Access Compliance Report

Public Rights-of-Way

(Curb Ramps)

Intersection ID: 14598	Main Street: N_CHASE_ST	Cross Street: RANDOLPH_RD	Location: SW
ADA ID: A01834E9F6EF	Ramp Type: Perp	Initial Pass/Fail: Pass	Overall Compliance: No
Severity Score: 22.5			
Codes/Mitigation Info/Possible Solution		Field Measurements/Component Compliance

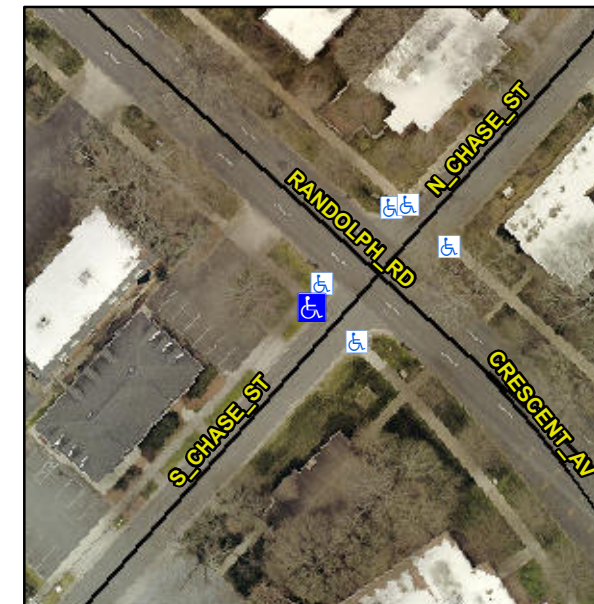
Not Found, R304.2.2-Perp, R304.3.2-Para, R304.2.3, R305.1.4, R302.7.2

Compliance	Description	Data	Compliance	Description	Data
N/A	Ramp Length (in)	70.0	Yes	Ramp Slope (%)	6.9
Yes	Ramp Width (in)	58.0	Yes	Ramp XSlope (%)	1.9
N/A	Flare Type LT	Sloped	N/A	Flare Type RT	N/A
N/A	Flare Slope LT (%)	7.2	No	Flare Slope RT (%)	13.4
N/A	Flare Traversable LT?	Yes	N/A	Flare Traversable RT?	Yes
Yes	Landing Length (in)	48.0	Yes	DWS Provided?	Yes
Yes	Landing Width (in)	53.0	Yes	DWS Contrast?	Yes
No	Landing Slope (%)	3.1	Yes	DWS Length (in)	25.0
Yes	Landing X Slope (%)	2.0	No	DWS Full Width?	No
N/A	Landing Curb? (Y/N)	No	Yes	DWS Offset (in)	2.0
N/A	Shared Landing?	No			
Yes	Gutter Ponding?	No	Yes	Gutter Slope (%)	0.9
No	Gutter Lip Ht (in)	2.0	Yes	Gutter X Slope (%)	0.0
N/A	Painted X Walk1?	No	N/A	Painted X Walk2?	N/A
	X Walk 1 Direction	To SE		X Walk 2 Direction	N/A
N/A	X Walk 1 Width (in)	N/A	N/A	X Walk 2 Width (in)	N/A
	X Walk 1 Slope (%)	8.1		X Walk 2 Slope (%)	N/A
	X Walk 1 X Slope (%)	1.3		X Walk 2 X Slope (%)	N/A

N/A	Ramp inside XWalk1?	N/A	N/A	Ramp inside XWalk2?	N/A
	Road Slope (%)	N/A	N/A	Clear Space?	Yes
	Road X Slope (%)	N/A	N/A	Clear Space to XWalk (in)	N/A
Yes	Any Obstructions?	No	Yes	Storm Grate/Utility Hazard?	No
	Obstruction Type			Storm Grate/Utility Type	
		N/A			N/A
			Yes	Surface Condition? (G/P)	Good

Possible Solutions:

Remove & Replace Entire Ramp.
